# Sonoma County Planning Commission **STAFF REPORT**

**FILE:** DRH16-0006  
**DATE:** August 3, 2017  
**TIME:** 1:30 PM  
**STAFF:** Georgia McDaniel, Project Planner

**Appellant:** Valley of the Moon Alliance (VOTMA)  
**Applicant:** Flora Li for Tohigh Investment  
**Owner:** Tohigh Investment SF LLC (Tohigh)  
**Location:** 900, 1200, 1202, and 1204 Campagna Lane, Kenwood  
APNs: 051-260-014 Supervisorial District No.: 1  
**Subject:** Appeal of Design Review approval for a new Inn, Spa, and Restaurant  
**PROPOSAL:** Request for final Design Review approval for an inn, spa, and restaurant on a 51.9 acre parcel.

Uphold the October 19, 2016 Design Review Committee approval of the revised project design and site plan modifications with two minor changes required by the Open Space Conservation Easement.

**A**  
4  
POOL SITE PLAN - CONCEPTUAL DESIGN  
SCALE: 1" = 20'

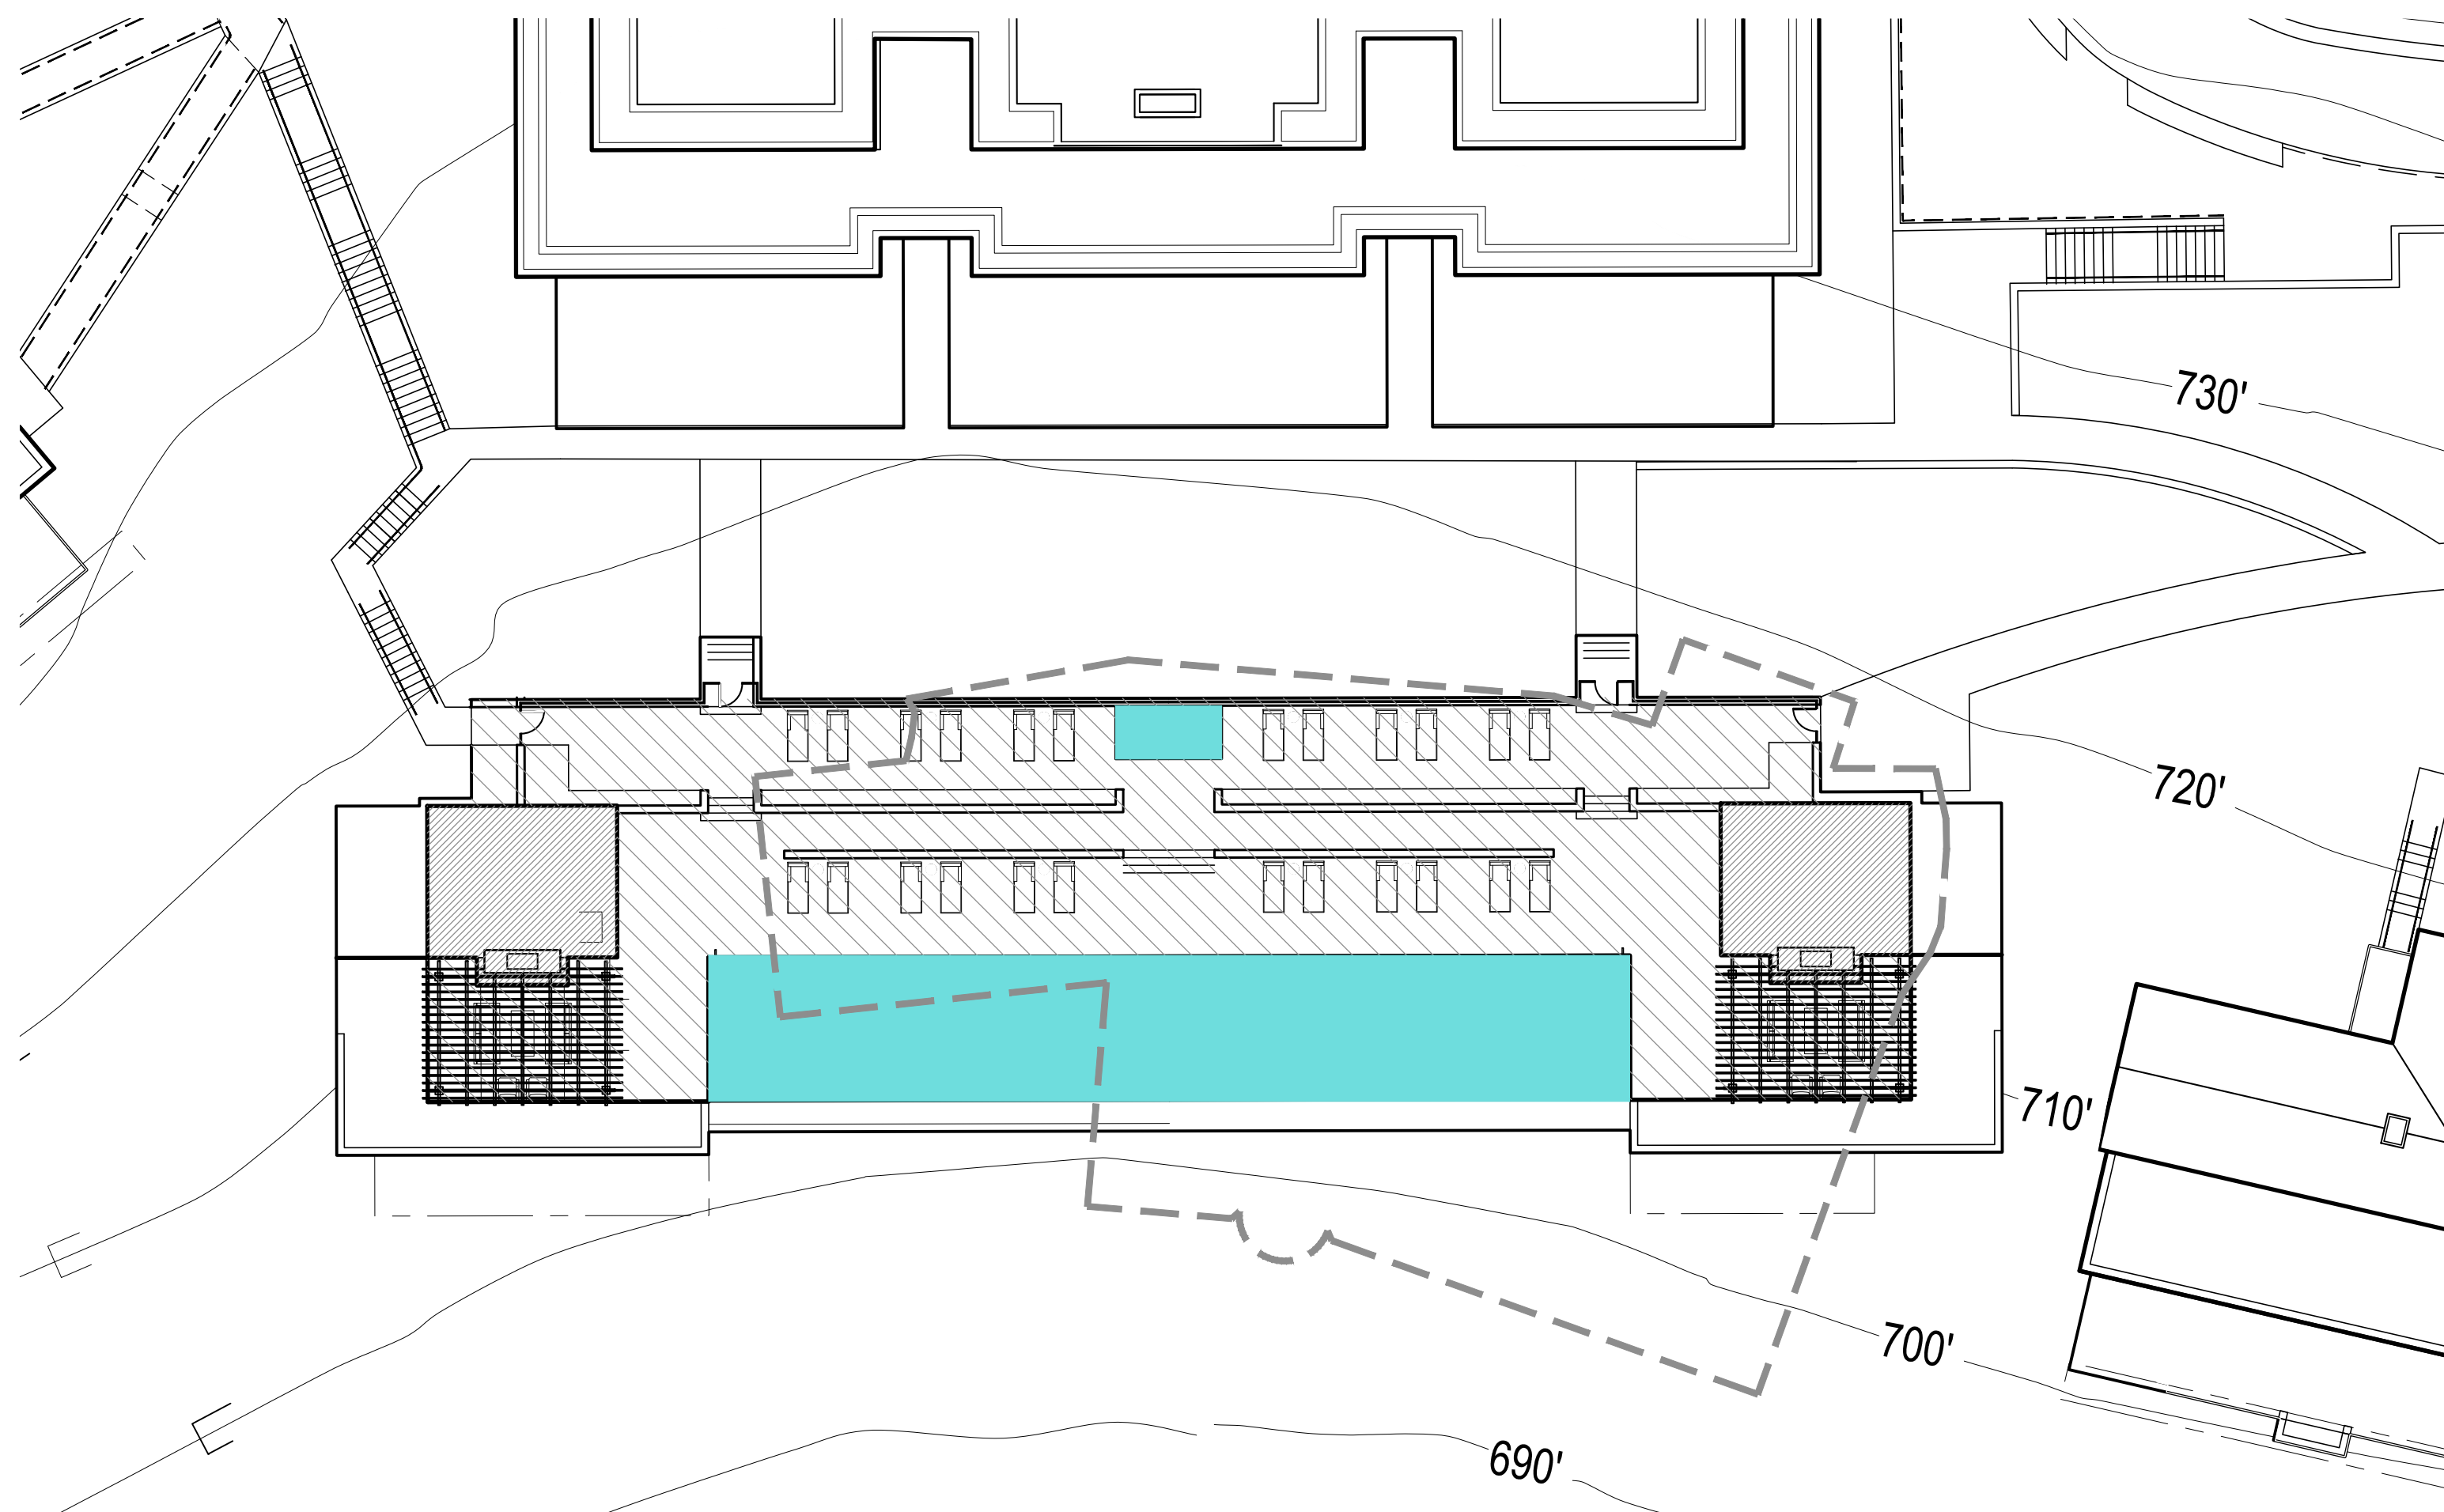
Tohigh's revised site design substitutes a large infinity pool with a south-facing lateral zero-edge drain flow for two smaller conventional pools that were shown in Exhibit 3.0-10. This design change presents several impact issues: Both the length and volume of the larger pool and the larger deck surface surrounding it, along with the southern water drain flow of the infinity design could present potential slope stability and failure issues, as well as seismic issues dissimilar from the original two static pools it replaces. No doubt the large pool deck would be a popular location for public day use, or day and night parties, if Tohigh was considering attempting to expand to that use. No indication is given whether the 2500 cubic yards of cut and/or the 500 cu yds of fill disclosed in the design application for the Inn/Spa/Restaurant will occur in or around this area. Infinity pools are more water-use intensive (more evaporation) and more energy intensive (more energy use for pumping) because the water level must be kept at a precise elevation. It is not clear that any of these issues were evaluated in the EIR for the original configuration. In any event, the new infinity pool would clearly be a significant new design feature of The Resort (see, bird's eye view of The Resort on first page of August 1, 2016 Kenwood Press). This significant design modification of the pool layout previously adopted by Condition of Use #84 exceeds the scope of the DRC's authority to ministerially approve this project.

The main pool location below the Inn for the proposed project design is similar to the conceptual design, but the total pool area has increased by 101 square feet. The conceptual design showed two pools plus a hot tub totaling 2,181 square feet. The proposed design has one main pool (2,184 square feet) with a main pool spa/hot tub (98 square feet) totaling 2,282 square feet. See BGK Summary of Impacts, Sheet 5. Also see Sheet 6 of the BGK Summary for design drawings comparison.
